**SANDMOUND SYSTEM
ON-SITE SEWAGE DISPOSAL SYSTEM
HOWARD COUNTY HEALTH DEPARTMENT
BUREAU OF ENVIRONMENTAL HEALTH
Tax ID # 04-371399**

SUBDIVISION: The Chase @ Stoney Brooke LOT NUMBER: 15

ADDRESS: 16326 Cattail River Drive PROPERTY OWNER: Trinity Quality Homes

Approved Septic System Plan
 Howard County Health Department

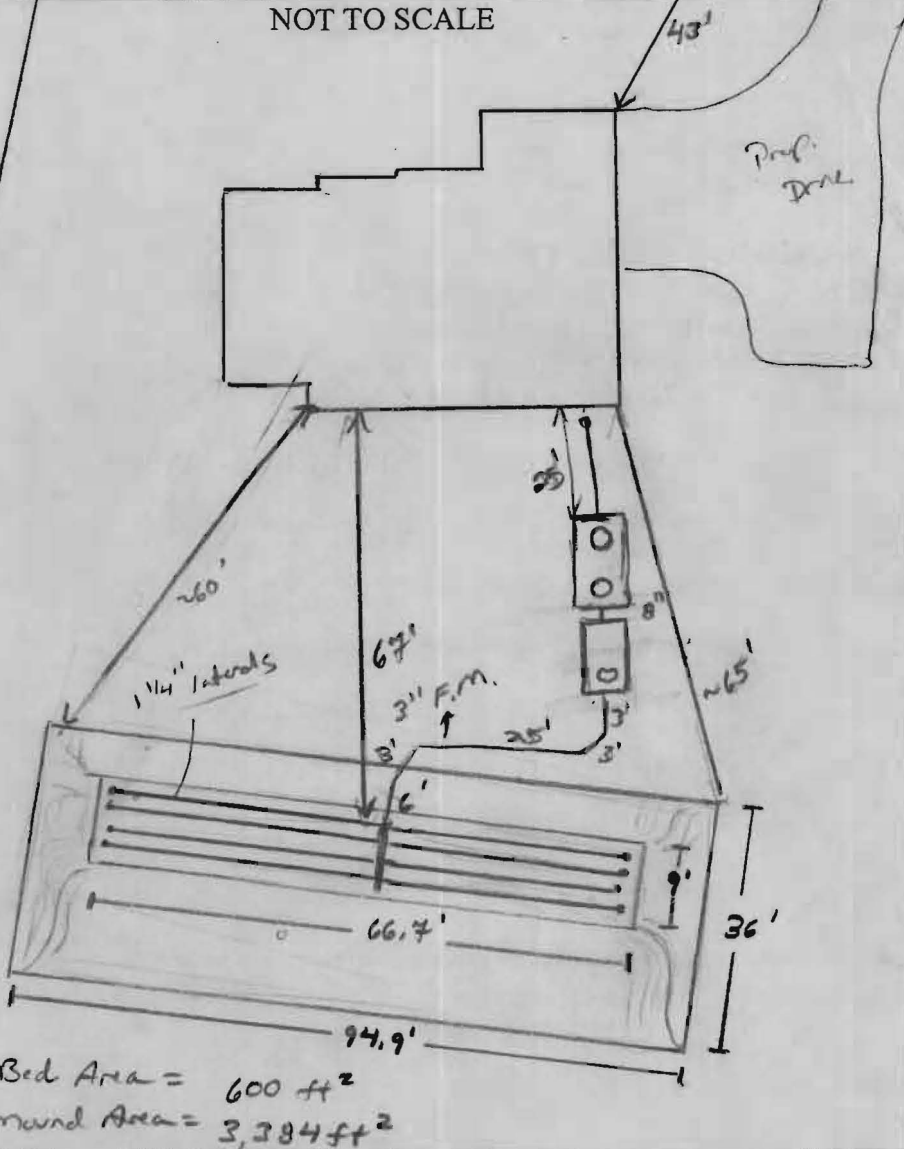
9/25/09 Spoke w/ contractor on phone (Freedom Style) OK to set tanks per plan. Sand approved. 9/29/09 Layout of mound and bed given. Top of mound dead level. was off by 4". Told contractor still too wet to plan. Soil 'wires' in 5 diff spots of mound. Both tanks set. slightly off of grade plan. Told contractor to let engineer know of these changes (Kw) 10/1/09 (Kw) Had Brian (HCHD) stop out @

side to check moisture content of soil. He said it was OK. but could wait till next week. Called contractor and told him he could plow ~10" but to cut grass first and let sit open (plowed) for a couple hours to dry out. before putting sand on (Kw) 10/2/09 mound shaped. Bed being cut. OK to continue (Kw) 10/6/09 Tanks set gravel in bed (~6") level, manifold and laterals set, pump test ran. Everything looks good. OK to cover bed w/ gravel, fabric and caps. (Kw) Need final P/A test @ 11/17/09 Attempted P/A test Alarm working. Pump not. (Kw)

FINAL INSPECTOR John Wall DATE OF APPROVAL 12/9/09
 12/9/09 Pump in pump tank pushed 1" per m.p. to get 2' discharge head. mound design calculations wrong. P/A test good. Sys complete

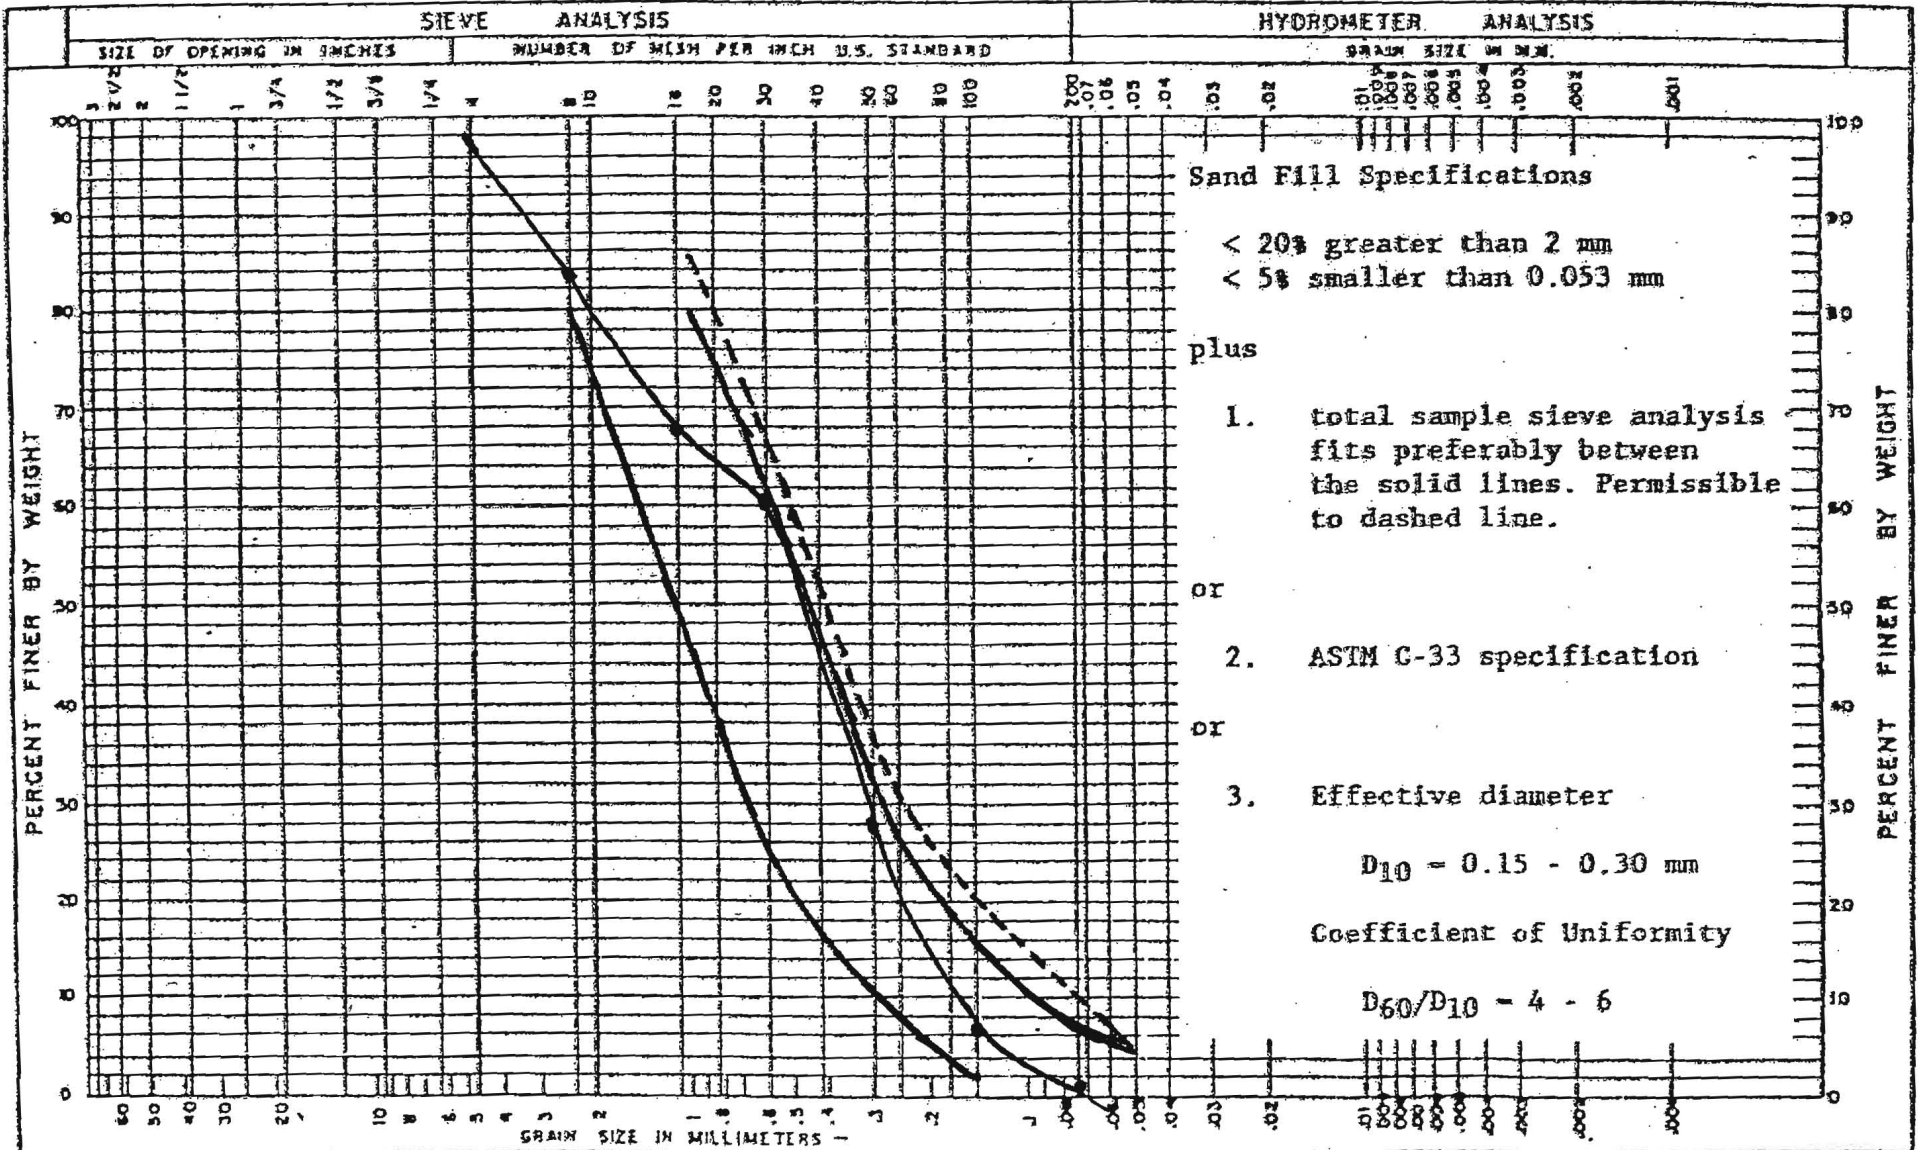
* Site visit confirmed on 10/2/09
 Proposed location for LP tank OK,
 Minimum 150' from all wells!
 Tank will be moved if not 100'
